## CENTREVILLE PLANNING COMMISSION

August 21, 2024

- VI. **Appearances**
  - a. Variance Request for Driveway/Walkway in the Critical Area Buffer – 110 Watson Rd, Darryl Savage, Owner
  - b. Concept Subdivision and Site Plan for proposed commercial development on proposed Lots N, O and P, Centreville Business Park, Coursevall, LLC, Owner; Kevin J. Shearon, P.E., LEED AP, DMS & Associates, LLC

**RE: CONCEPT SUBDIVISION AND SITE PLAN FOR A PROPOSED  
COMMERCIAL DEVELOPMENT ON PROPOSED LOTS N, O, AND P IN THE  
CENTREVILLE BUSINESS PARK, LANDS OF COURSEVALL, LLC  
Q.A. COUNTY TAX MAP 44E, PARCEL 98  
DMS & ASSOCIATES JOB #2023124**

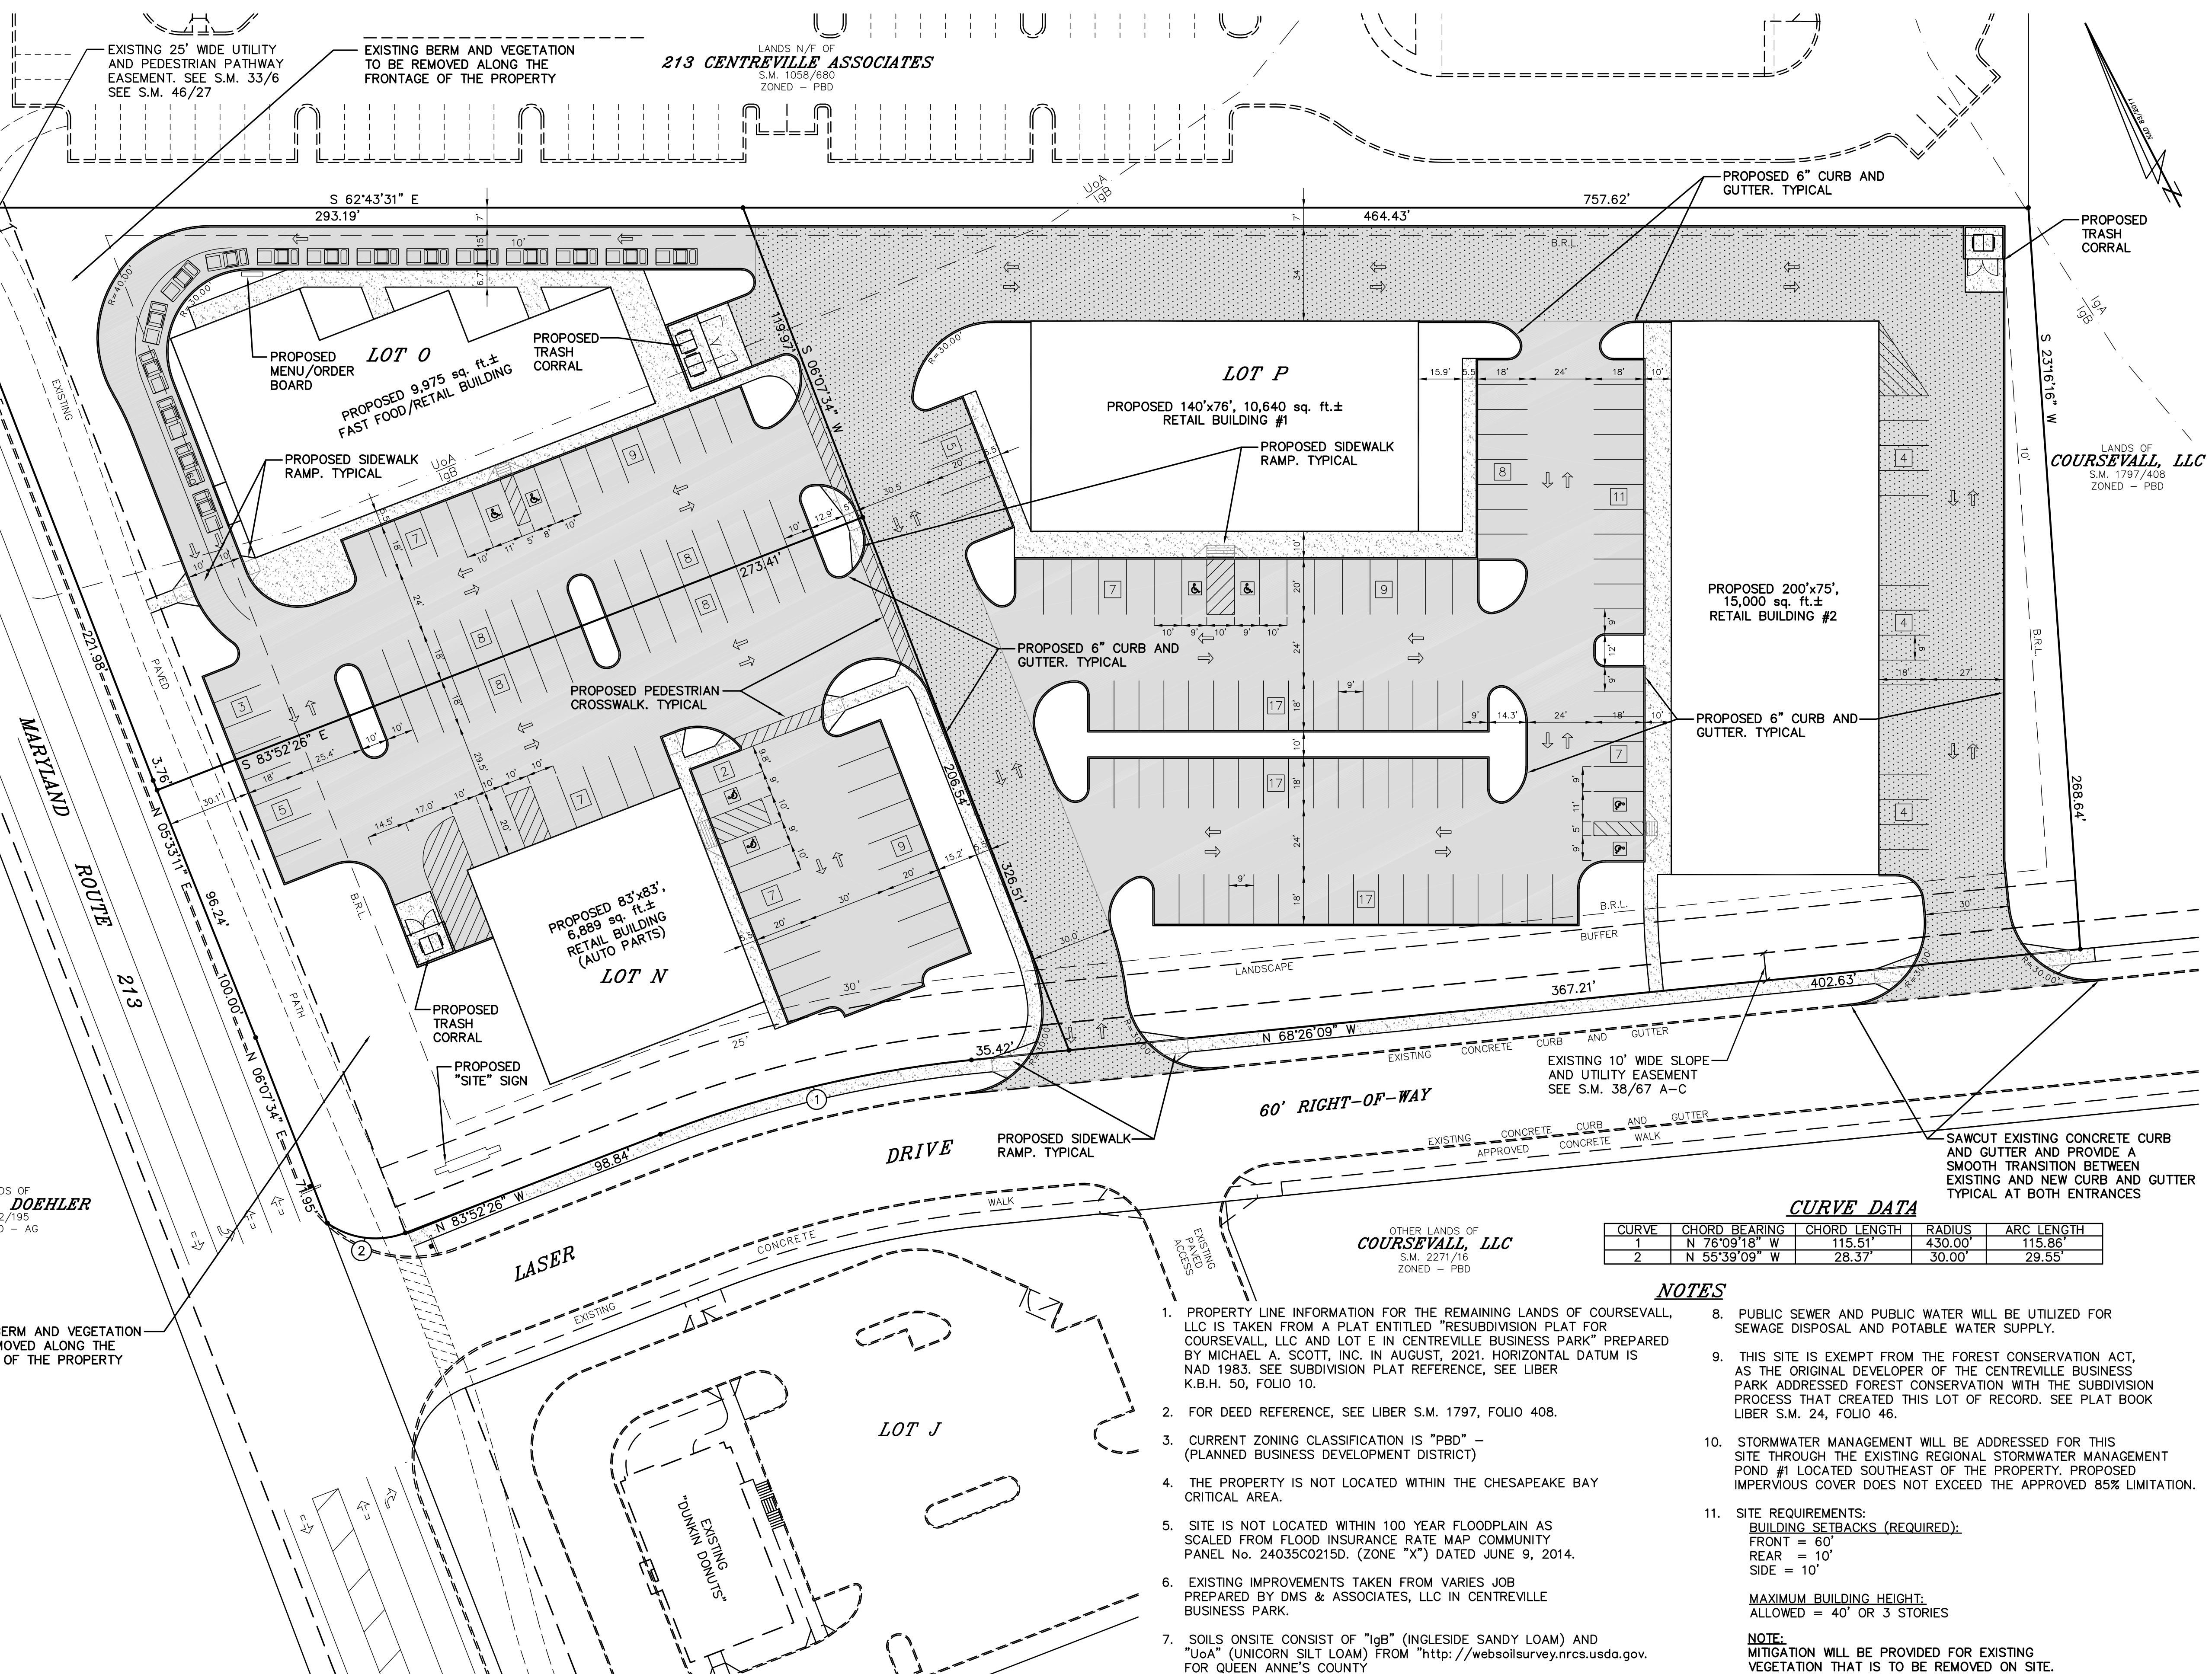
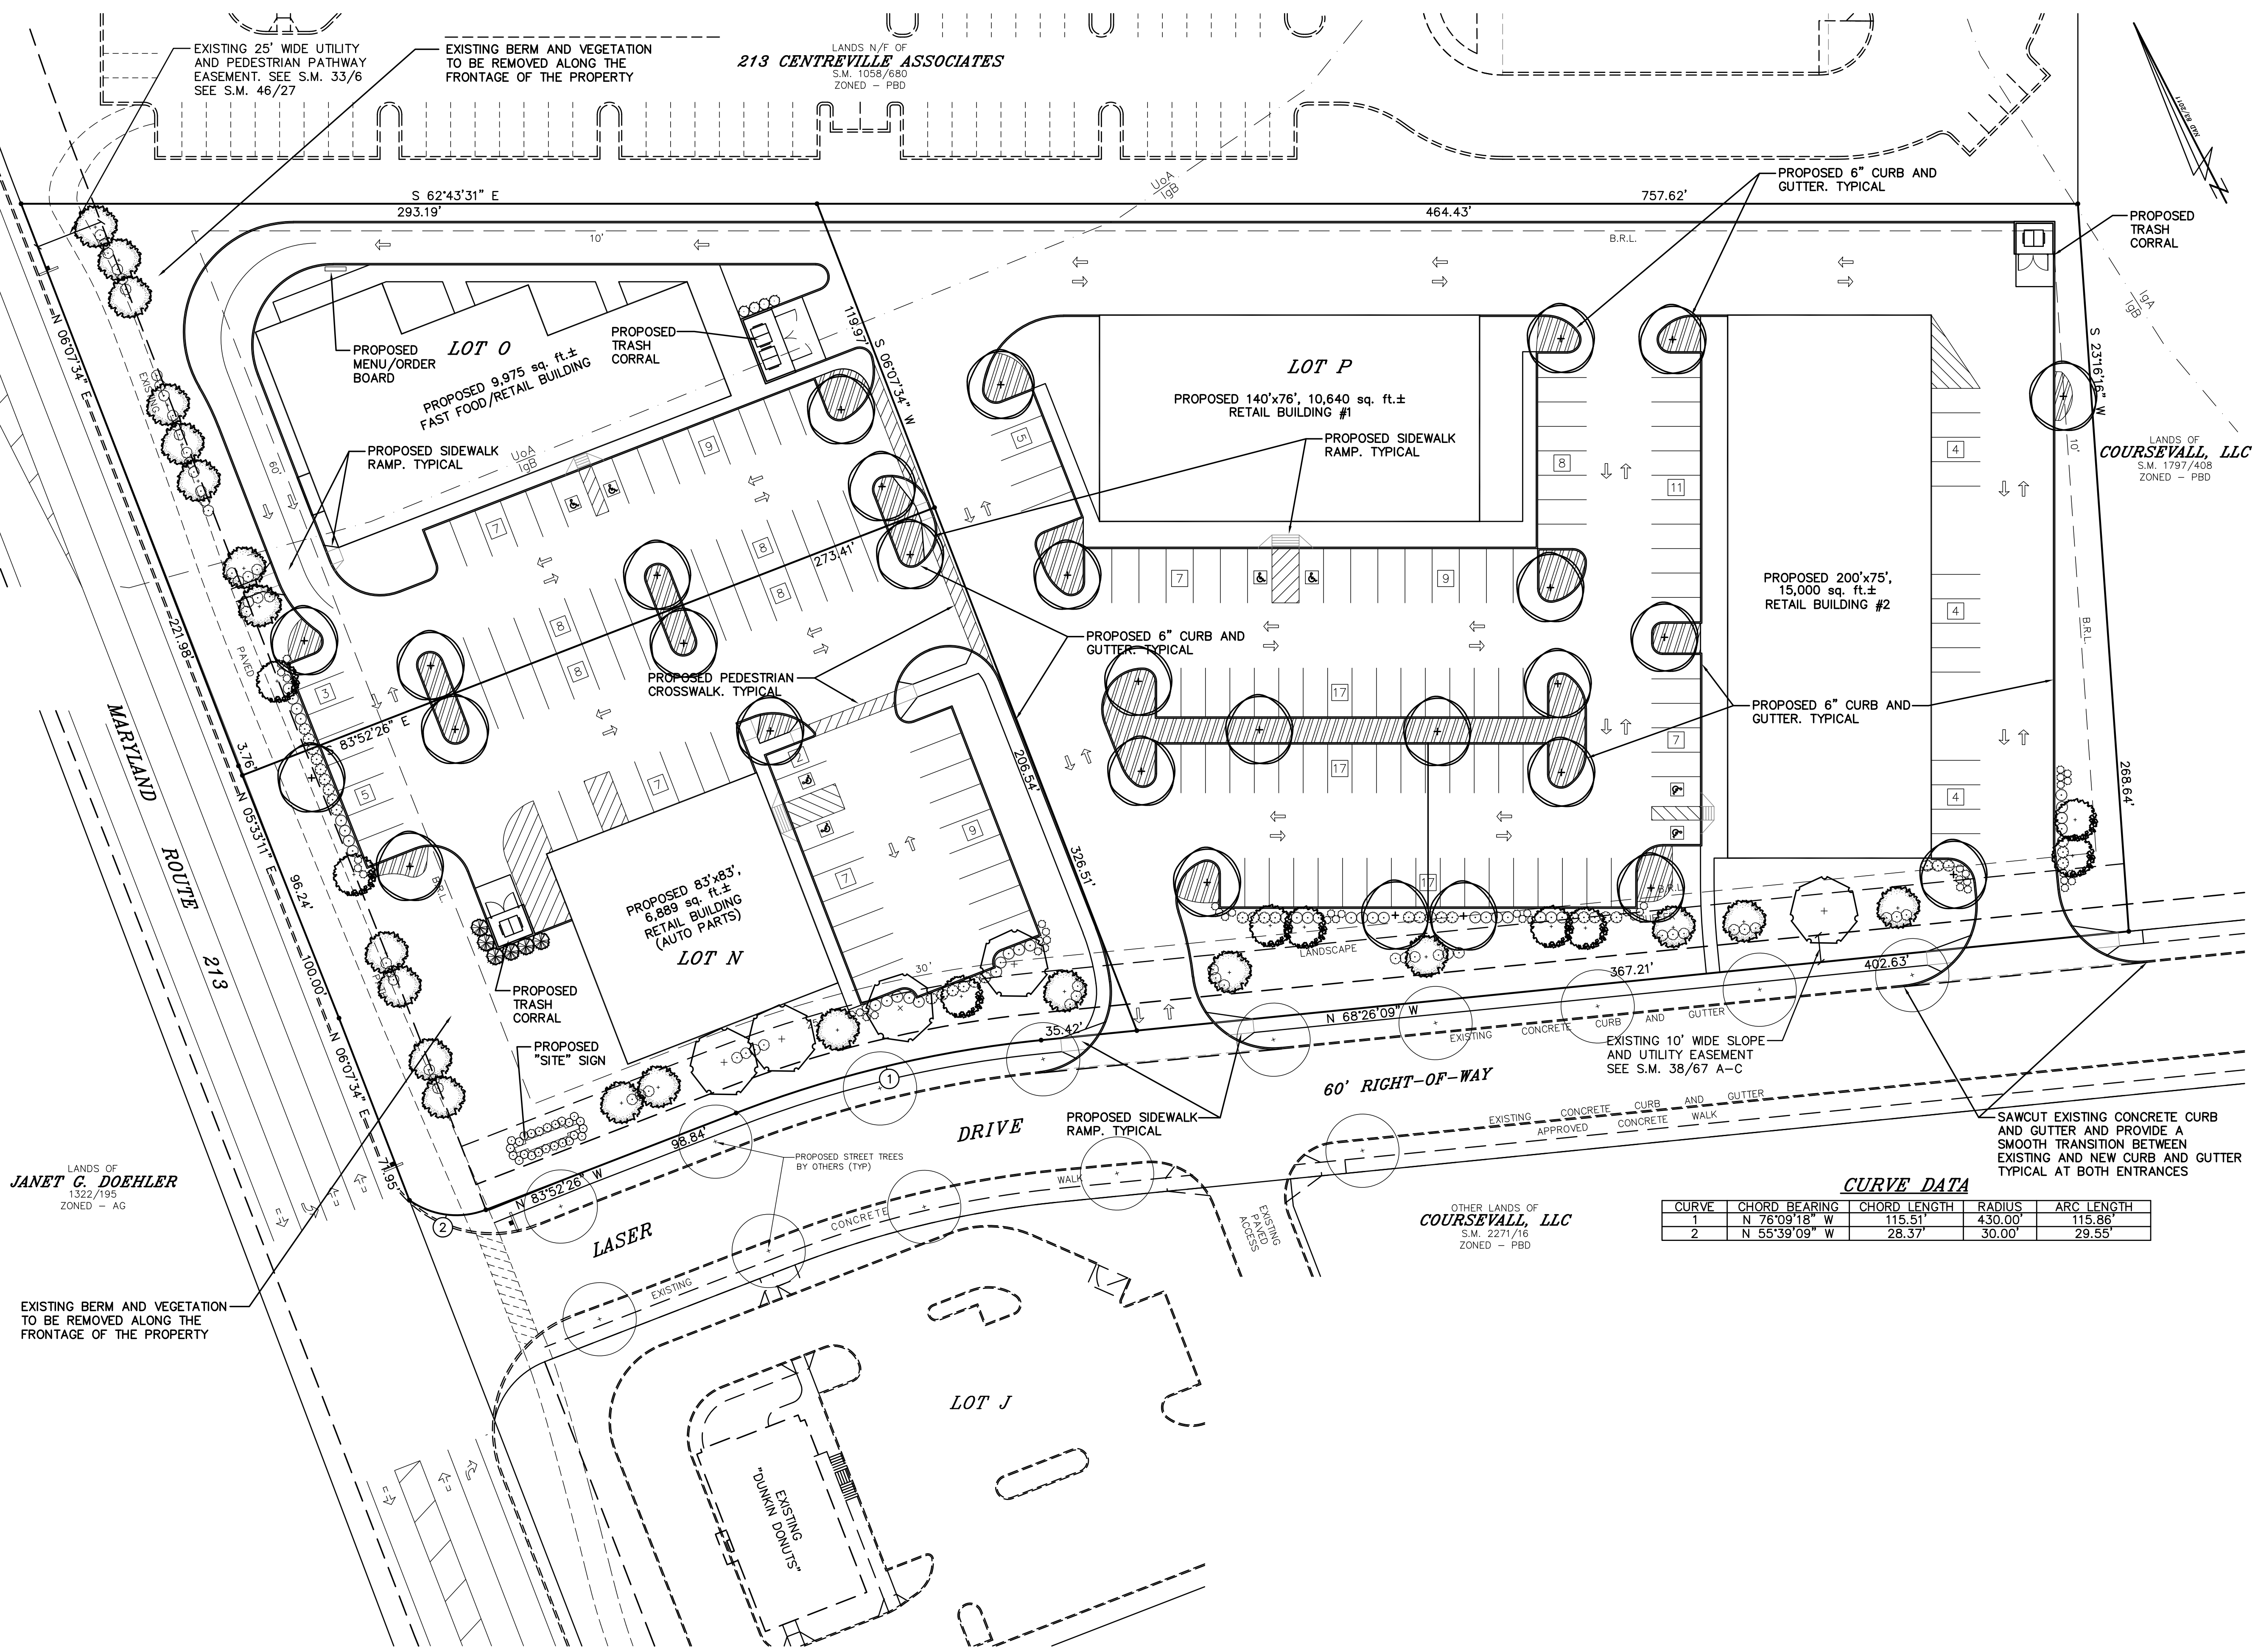
- The “wooded patch” along Laser Drive is volunteer growth from a left over topsoil stockpile area. The area will be cleared prior to work commencing on this project. We do not feel that the volunteer growth warrants the need for mitigation. The landscaped berm along MD Rte 213 however was an initially planted screen. We will provide mitigation for the removal of this vegetation in the formal site plans following Concept Plan review.

- A trash corral has been located in the back corner of Lot P. The main entrance has been revised to come in normal to Laser Drive. We have separate the parking lot on Lot P to provide a 10-ft wide landscape island.

- Parking has been indicated on the back side of the easternmost building on Lot P.
- NAD information has been added to the north arrow.
- As noted above, the resulting pedestrian easement width on this site is 25-ft.

- We will review the subdivision categorization with the town following Concept Plan review.
- A landscape plan will be developed following Concept Plan review. The street trees will be included per the originally approved plans for Laser Drive.
